<b>Office Action Summary</b>	<b>Application No.</b> 10/598,728	<b>Applicant(s)</b> JUNTUNEN, HARRI	
	<b>Examiner</b> Jeffrey O'Brien	<b>Art Unit</b> 3677

## **DETAILED ACTION**

**Annotated Fig. 2b**

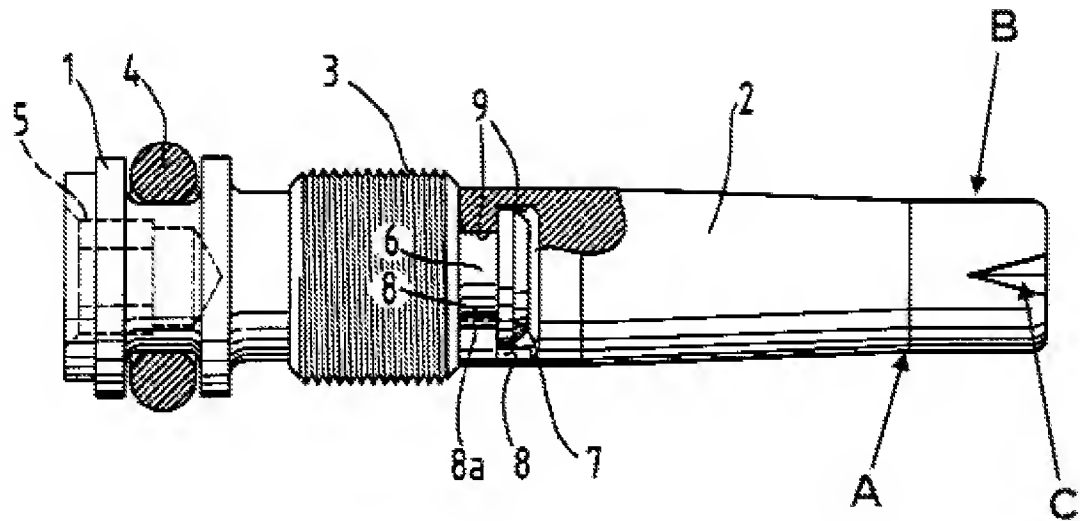
5. For Claim 13, APA discloses each and every element except for a support part and a collar of resilient material surrounding the support part of the control device, the collar being under compression whereby the collar supports the second end of the control device relative to the door closer body and restrains the control device against rocking and swaying movement relative to the door closer body due to flow of pressure medium in said channel. '444 teaches a support part (A) a collar (Annotated Fig. 2b: B) of resilient material (Column 3, Lines 10-11) surrounding a support part (A) of a control device (2), whereby the collar is capable of supporting the second end of the control device relative to the door closer body and restraining the control device against rocking and swaying movement relative to the door closer body due to flow of pressure medium in a channel. It is further noted that APA as modified by '444 would cause the collar to be compressed or pressed together with the housing of the blind hole segment of APA as seen in Fig. 2. It would have been obvious to one of ordinary skill in the art at the time the invention was made to replace the control device of APA with the control device of '444 in order to allow the control device to be made of a separate material, which provides for selecting the materials according to the qualities required of each

part, simplicity of manufacture and manufacturing costs, one would further be motivated to apply the control device of '444 Figure 2 because it is formed of a solid material (Column 4, Lines 1-5) and is more rigid (less flexible) than the hollow body of Fig. 1. This lack of flexibility provided by the solid and longer extending piece of Fig. 2 of '444 is therefore capable of restraining the control device against rocking and swaying.

6. For Claim 14, '444 further teaches wherein the collar (B) has at least one chase (C) to reduce its thickness at a certain part of the collar.

7. For Claim 15, '444 further teaches wherein the collar (B) is plastic (Column 3, Lines 10-11).

8. For Claim 16, '444 further teaches wherein the collar (B) is plastic (Column 3, Lines 10-11) and has at least one chase (C) to reduce its thickness at a certain part of the collar.

11. For Claims 24 and 26, APA in view of '444 further teaches wherein the support part (A) of the control device is smaller in diameter than the control part (35/2).

3. Applicant further argues that the element B shown in annotated Fig. 2b of '444 does show a collar because it is not a short ring formed on a rod or shaft as a locating or holding part. However, collar can be taken to mean "any of various ringlike devices used to limit, guide or secure a machine part". Element B as shown in Fig. 2b is ringlike and can be used to limit, guide and secure the control device into the bore of a door closer.
